# AIR COMMERCE PARK 3650 8TH STREET

## SUMMARY

## Minor Subdivision Plat

# BOUNDARY SURVEY

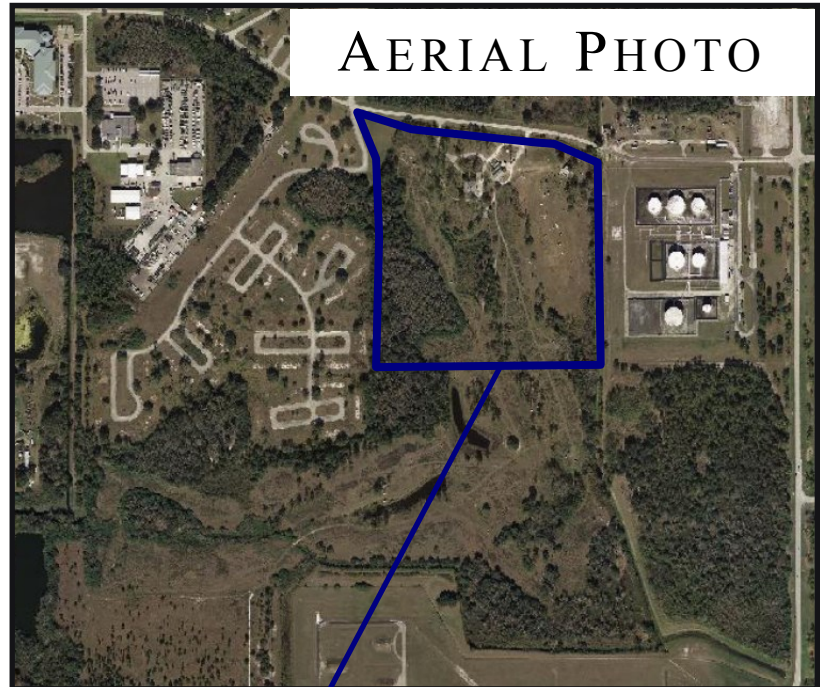
1. The plat you have submitted for the First time called Air Commerce Park has not passed the review process for the following reasons:
  1. Sheets: (Surveys) Please show on the survey the ties of the monumented lines referenced bearing basis in note #8.

2. Sheets: (Surveys) Show the monumentation from the POC and clearly label the POB.
  3. Sheets: (Surveys & Plat) Add the recording reference onto Ave "C".

4. Sheets: (Surveys) Add the minimum of two site benchmarks.FAC 5J17.052 (12)  
Topographic Survey (a) Note 9 "88" Datum needs to be added.
  5. Sheets: (Surveys) There is difference in a bearing of the line and description of S68-26-26W and differences of three distances of 1175.42', 1331.75' and 82.00'.

6. Sheets: (Surveys) The certification needs to be updated to the Standards of Practice language.
  7. Sheet: (Plat) The title on the plat and dedication need to be the same.

# PROPOSED PLAT-AIR COMMERCE PD TRACT A

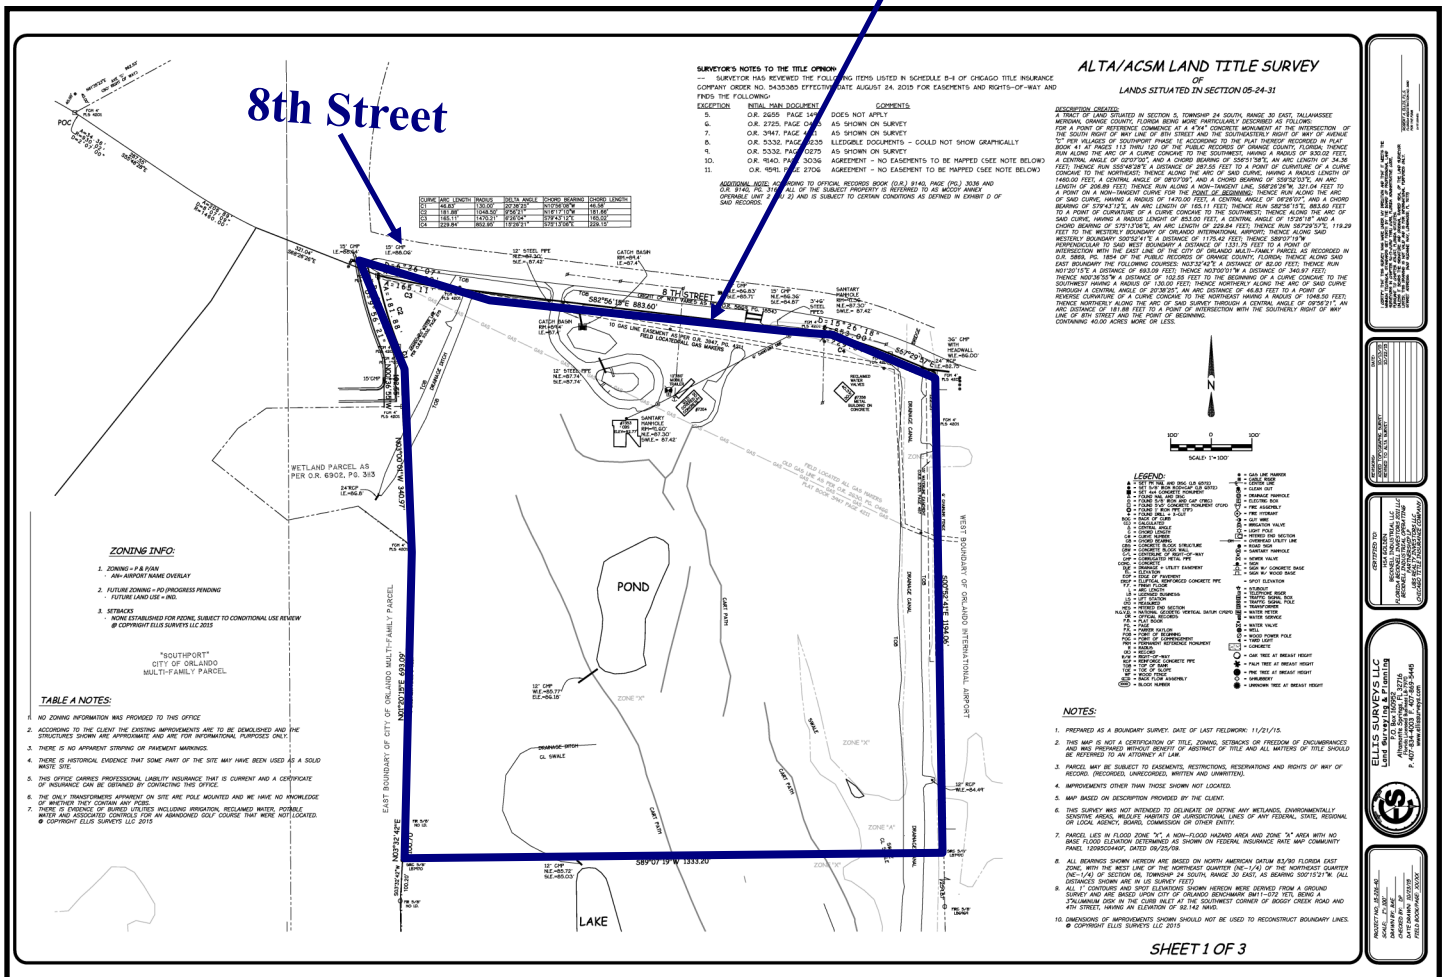
8. Sheet: (Plat) The owner on the plat isn't the same as the opinion letter.
  9. Sheet: (Plat) Show the monumented line of the referenced bearing basis.

10. Sheet: (Plat) Add the section, township and range with the city, county and state.
  11. Sheet: (Plat) Check the line bearings and distances from the POB to match with the curve data and legal description correctly. Typo in length at 853.00' desc.

12. Sheet: (Plat) The dedication makes mention of right of ways and easements that haven't been created and if that's the case it needs to be added as "hereby dedicates nothing to the public" or to that effect.

13. Sheet: (Plat) The easements that aren't coincident with property lines must be labeled with bearings and distances and tied to the lot, tract or right of way.

14. Sheet: (Plat) The lot or tract needs to be number or lettered.
  15. Sheet: (Plat) The boundary needs to be tied to 2 public land corners as defined in FS 177.503 and CCR numbers shown.

18. Sheet: (Plat) Add Not Platted to all contiguous property.
  19. Sheet: (Plat) Please use the examples of the dedication blocks Certificate of Approval versions of the Appendix C in the Final Plat Review Checklist.
